UTS Broadway Concept Plan

*Modification of
Concept Approval
(MP 08_0116 MOD 6)*

January 2020

Figure 11 | Amended building envelope (Base source: Proponent's Supplementary RtS 28.09.19)

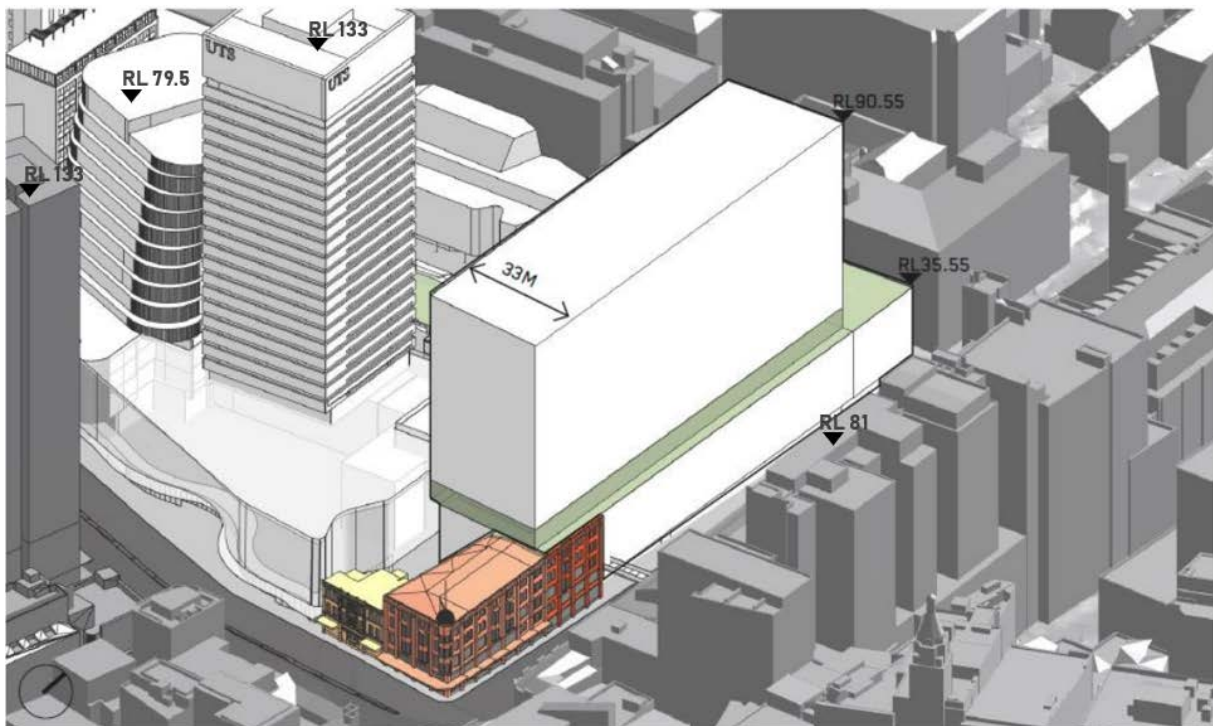
The Department supports the changes made to the building envelope to address Council's concerns. The increased tower setbacks ensure the prominence of the Bon Marche building is retained and establish a clear podium in line with the Bon Marche parapet datum. The ground level setback also provides a significant improvement to the public domain along Harris Street.

The Proponent has agreed to provide a minimum two storey height clearance between the ground floor and the underside of the podium, however the submitted plans show only a one storey (approximately 5 m) clearance adjacent to the Bon Marche building. The Department therefore recommends a condition requiring future applications to provide a minimum two storey clearance from the ground floor to the underside of the podium for the full length of the new building envelope along Harris Street.

Figure 13 | George Street – Railway Square bus stands (PD1) (Base source: Proponent's VIA)

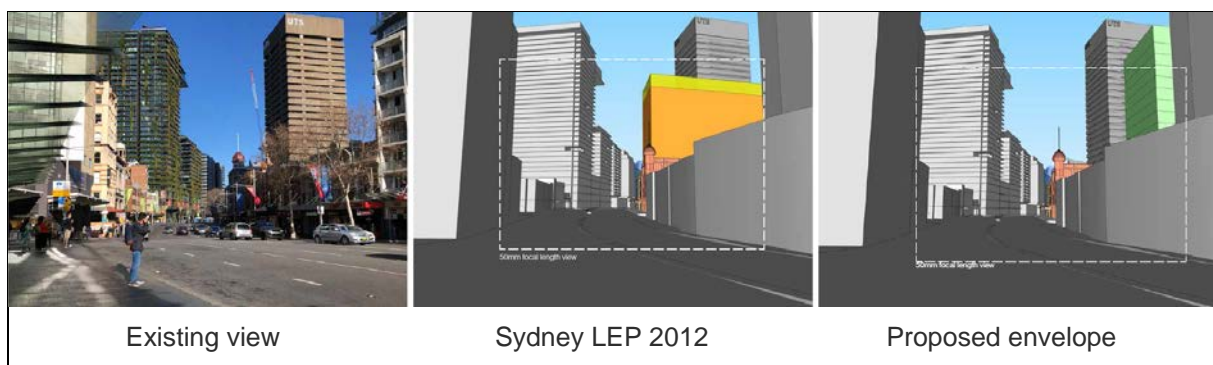
The VIA identified the most significant views (shown by the blue dashed circles in **Figure 12**) impacted by the proposal would be from:

- the Railway Square bus stands on George Street (**Figure 13**),
- the corner of George Street and Regent Street (**Figure 14**)
- the Alumni Green (**Figure 15**).

Views from these locations are short-term passing views, with the exception of the view from Alumni Green which is also a static view from users of this space. Each of these views is of moderate to high significance due to the high traffic locations, attractiveness of the space and quality of elements within view.

Figure 17 | One Central Park East – Level 16 view analysis (Source: Proponent's VIA)

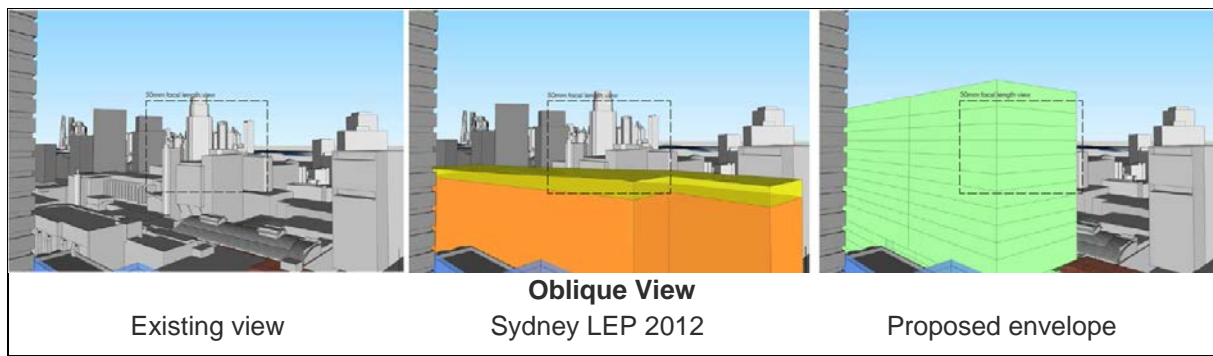
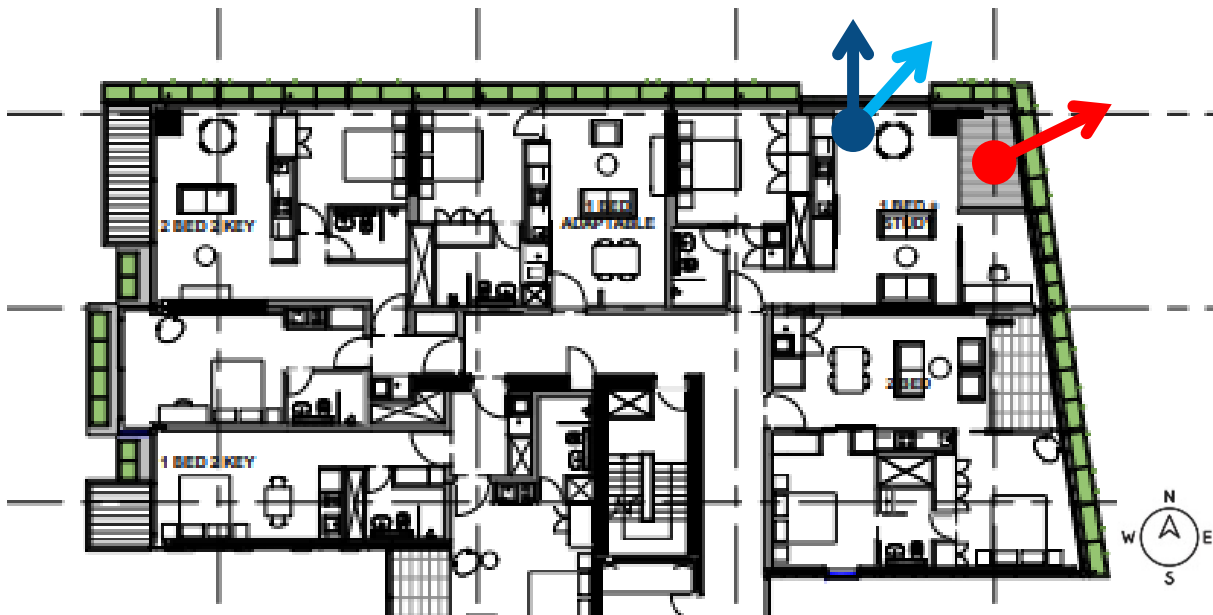
Apartments on the northeast corner of One Central Park East have partially obstructed oblique views of the city skyline and Barangaroo. The views are available from living areas and private open spaces and are rated in the VIA as moderate to high. The VIA shows the impact on views from an apartment on Level 16 which is representative of views from apartments across Levels 14 to 21 in One Central Park East (**Figure 17**). The proposal obstructs views of the city skyline and Barangaroo, however many of these apartments will continue to enjoy views east towards Central Station from living areas and private open spaces. (**Figure 18**).

Figure 19 | Taragon Central – Level 16 view analysis (Source: Proponent's VIA)

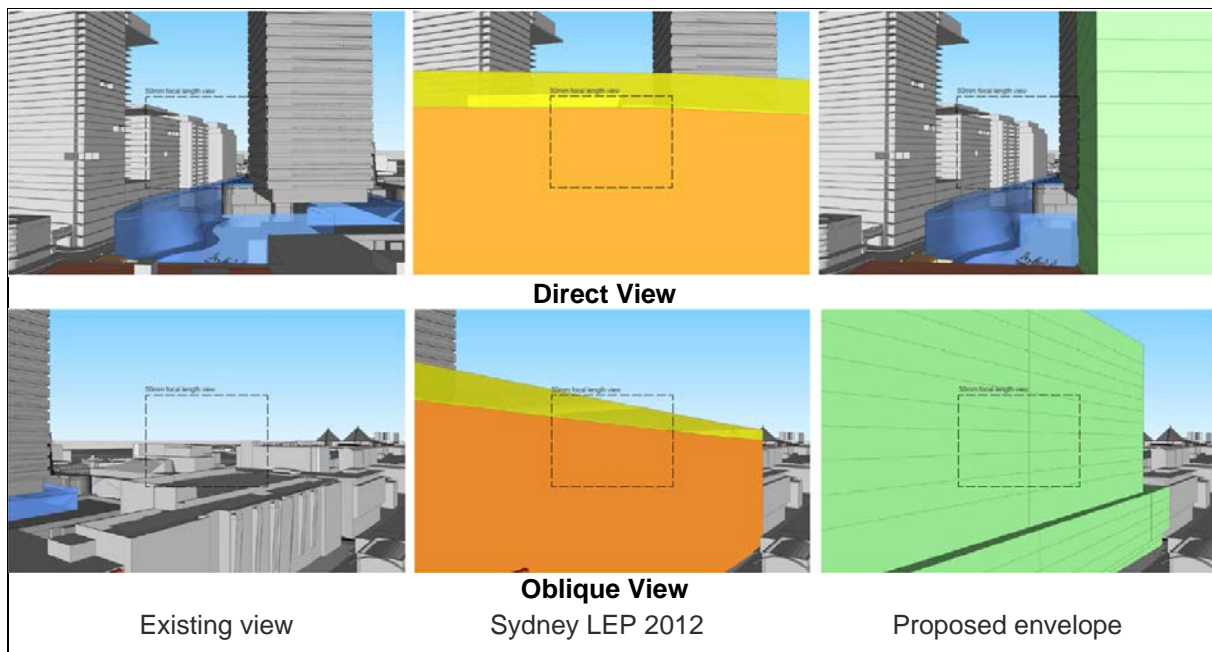
Apartments on the south-west elevation of Taragon Central have direct views of Building 1 on the UTS site as well as One Central Park and Duo within Central Park. Apartments also have oblique views of the Anzac Bridge and glimpses of water. The views are rated in the VIA as moderate to high. The VIA shows the impact on views from an apartment on Level 16 which is representative of views from apartments across other levels in Taragon Central (**Figure 19**).

The proposal obstructs views of the sky, though the proposal is particularly dominant in the oblique view. The proposal maintains a view corridor along Broadway. Oblique views of the Anzac Bridge and water would be partially obstructed by the proposal. However some views towards Pyrmont would be retained.

Figure 20 | Hightown - Level 9 view analysis (Source: Proponent's VIA)

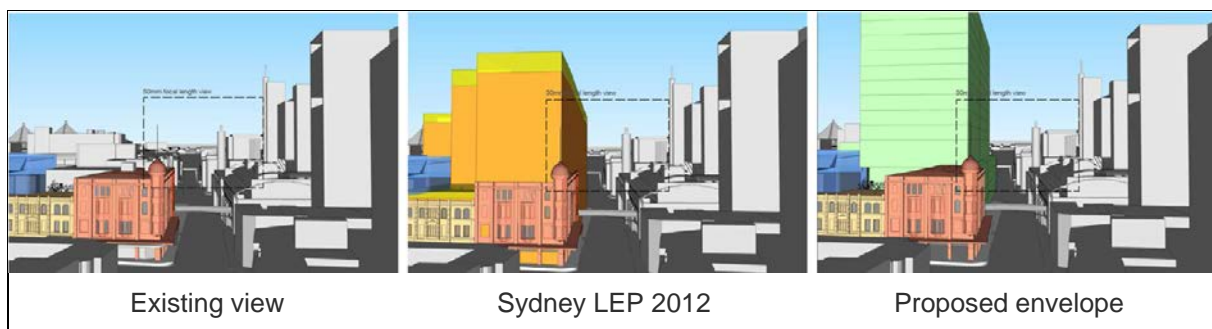
Apartments on the north-west elevation of Hightown have direct views of the Bon Marche building, Harris Street corridor and obstructed views of the Anzac Bridge and distant water views beyond Pyrmont. These apartments also have oblique views of the Anzac Bridge and glimpses of water. The views are rated in the VIA as moderate to high. The VIA shows the impact on views from an apartment on Level 9 which is representative of views from apartments across other levels in Hightown (**Figure 20**).

The proposal partially obstructs views of the sky, Anzac Bridge and potential water views. However framed views down Harris Street towards Pyrmont will be retained.
